# TOWN OF LAKEVILLE MEETING POSTING & AGENDA

RE: Stowe Estates, Lakeville, MA

This letter is written to respond to the review comments on the subject project which were included in a letter dated April 23, 2023, issued by the Board's review engineer, Environmental Partners (EP). The responses below correspond to the numbered comments from EP.

**DEFINITIVE SUBDIVISION GRADING & DRAINAGE PLAN**  
STOWE ESTATES  
LAKEVILLE, MASSACHUSETTS  
JJI PROPERTIES, INC.  
6 SAND TRAP LANE  
LAKEVILLE, MASSACHUSETTS

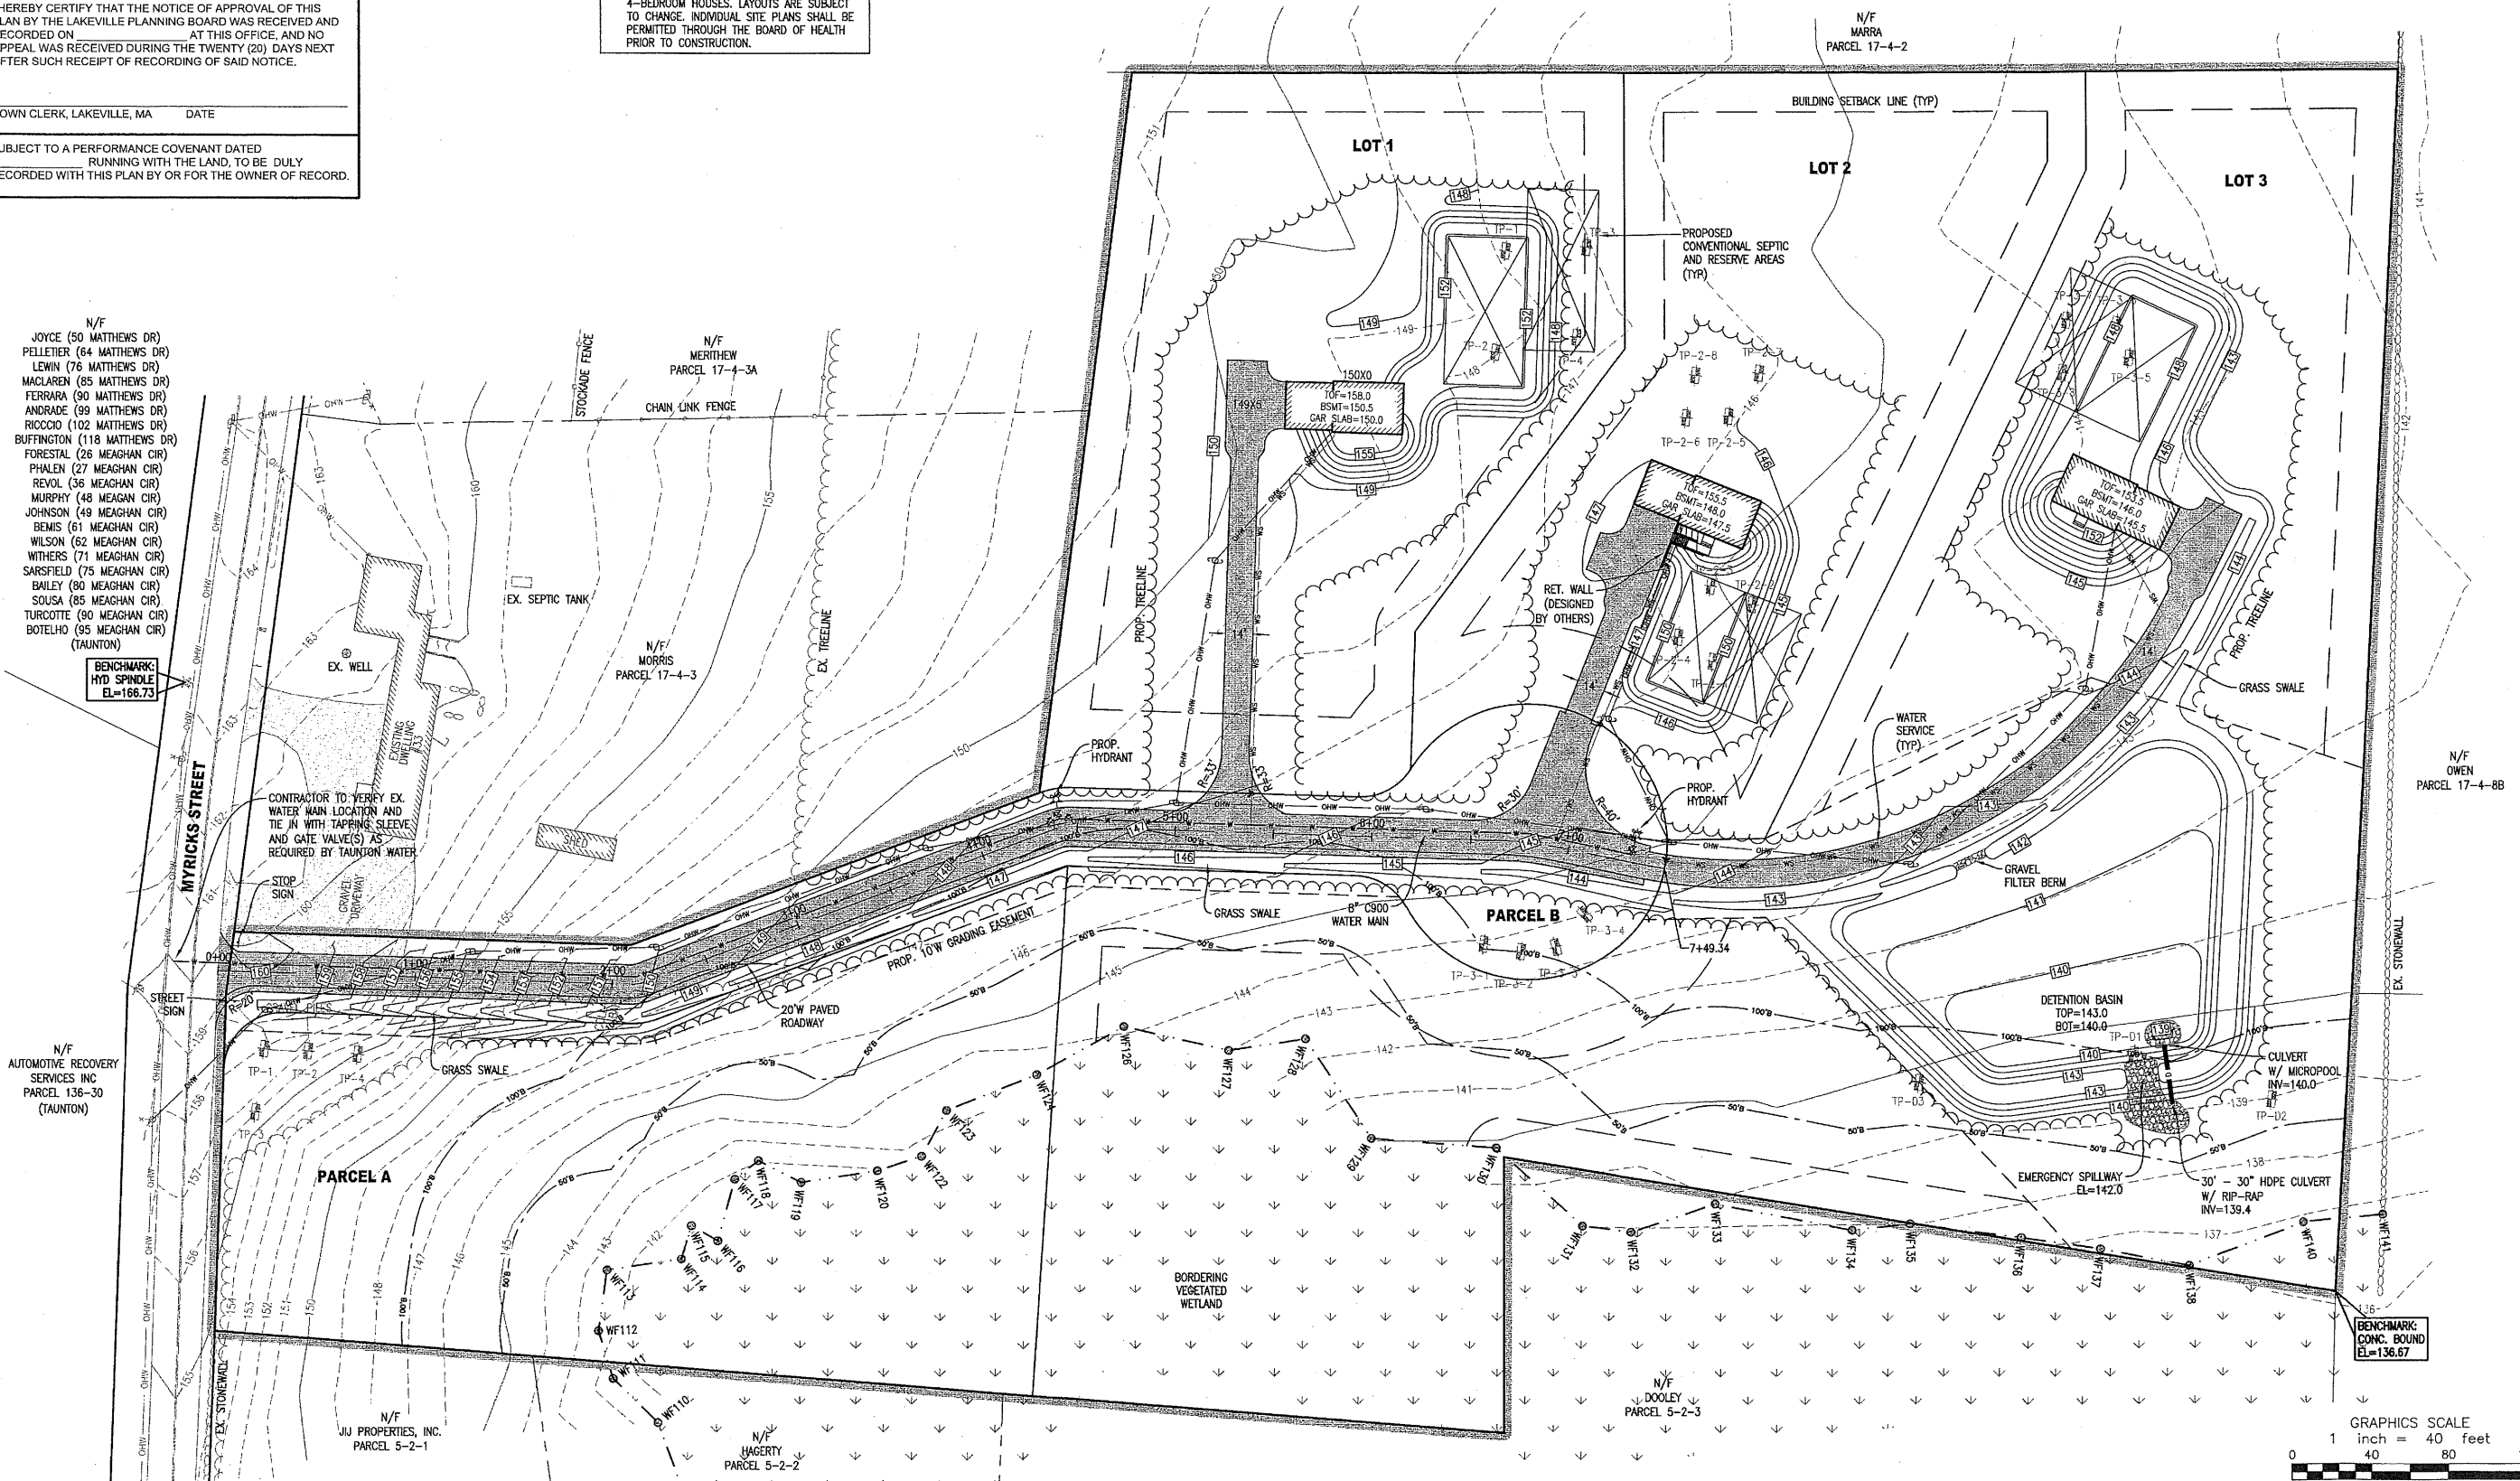
3. **EP: Section III.C.2.k requires building setback lines be included on the plans. The plans do not include any building setback lines.**

- 35. EP: Section IV.H requires street signs. The plans do not include street signs.**

Response: Building setback lines have been added to the Grading and Drainage Plan.

Response: A street sign is specified on the Grading and Drainage Plan on the southern side of the intersection.

**PROFILE VIEW**  
HORIZONTAL SCALE: 1"=40'  
VERTICAL SCALE: 1"=4'

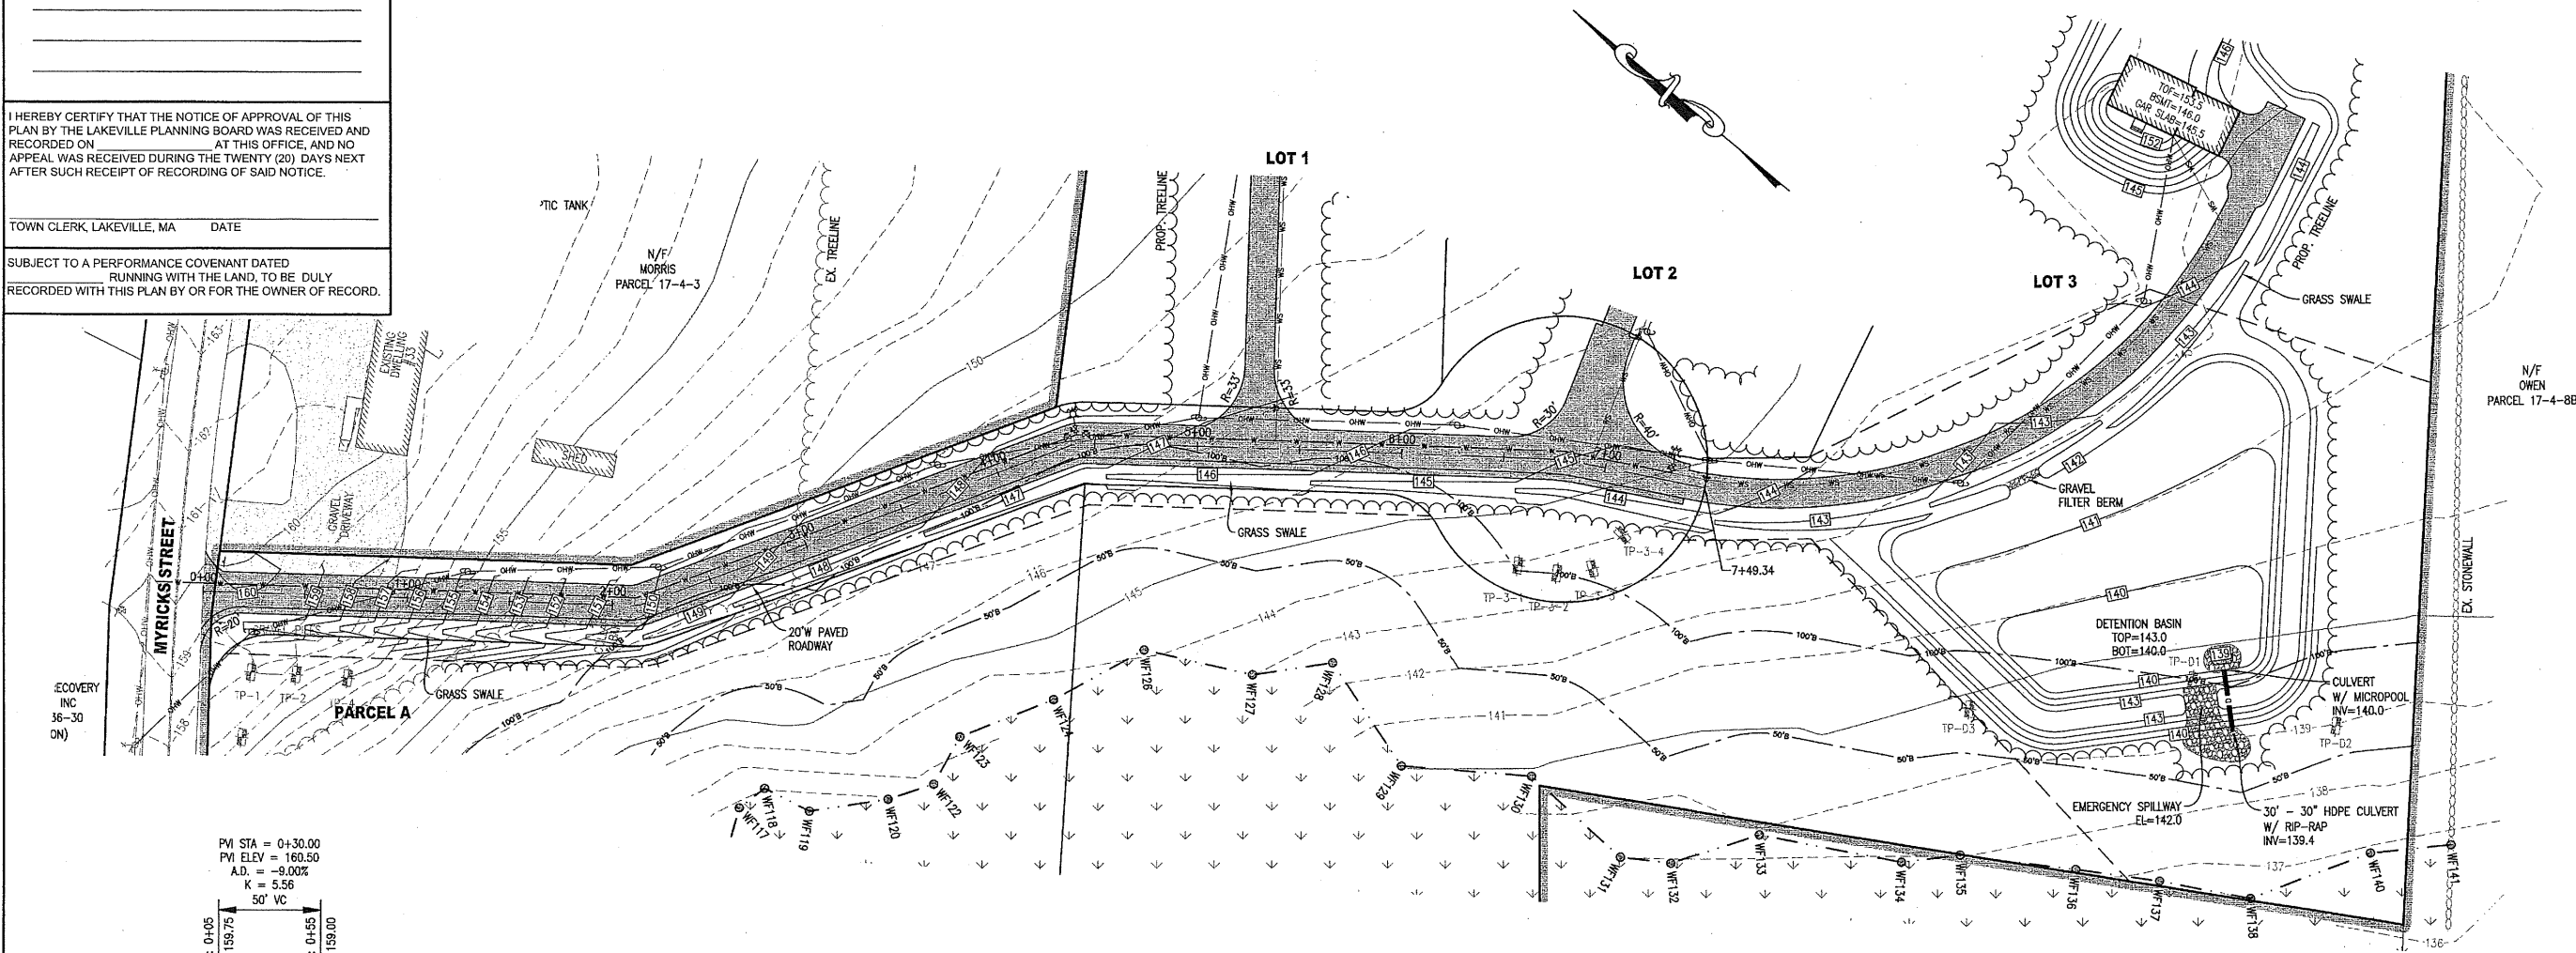
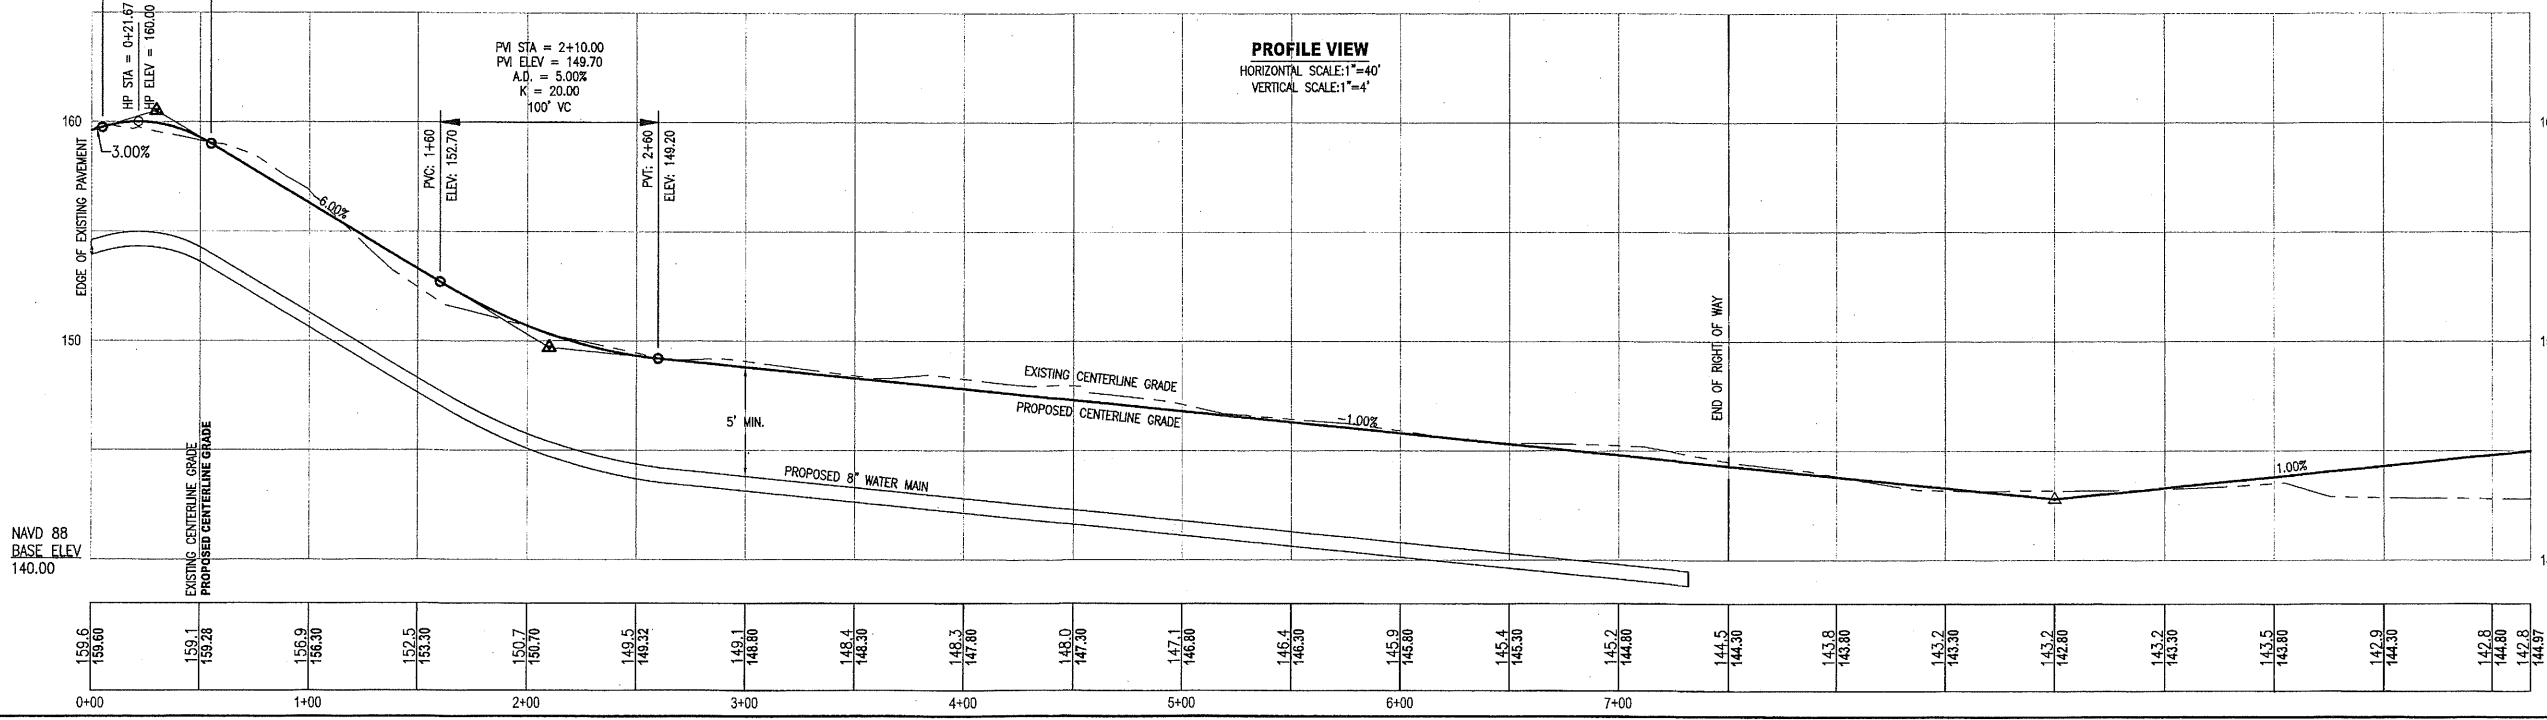
5. **EP: Section III.C.2.o requires the proposed layout and utilities to be shown on plan and profile sheets. The plans show proposed water and electric service on the Grading and Drainage Plans. They are not shown on the proposed road profile.**

Response: The proposed water and electric services have been added to the Roadway Profile Plan.

**ROADWAY CROSS SECTION DETAIL**  
NOT TO SCALE

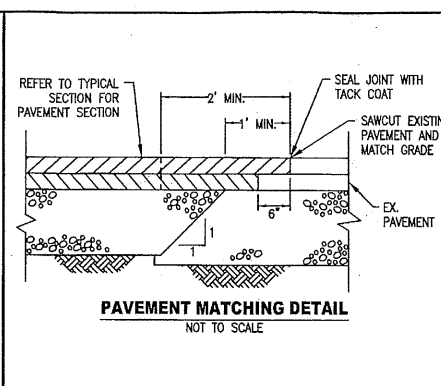
- 17. EP: Section IV.B.6.g requires the minimum roadway width for Minor Streets be twenty-four feet. The proposed cross section includes a 14 foot wide pavement width with a 3 foot wide gravel strip on either side of the pavement. The Roadway Cross Section Detail labels the road width as twenty feet. This includes the fourteen foot pavement and three foot gravel strips. The detail describes the 3-foot gravel strips as processed gravel. We recommend more detail be provided for this specification, consistent with MassDOT Standard Specifications. We assume this is proposed to be ¾-1-1/2 inch crushed stone, but the applicant should specify. The applicant has requested a waiver for reducing the width from twenty-four feet to fourteen feet with 3 foot wide gravel shoulders.**

- 18. EP: Section IV.B.6.h requires roadway pavement to be Class I Bituminous Concrete Pavement Type I-1. This type of pavement should be specified on the detail.**

10. **EP: The roadway cross section detail shows the side slopes of the drainage swale to be 2:1. We recommend this slope be flattened to a minimum of 3:1 to ensure adequate stabilization and maintenance, including mowing.**

Response: The Roadway Cross-Section Detail has been revised to specify gravel shoulder requirements.

Response: The Roadway Cross-Section Detail has been revised to specify Type I-1 pavement.

Response: Swale sideslopes have been revised to be 3:1 slopes.
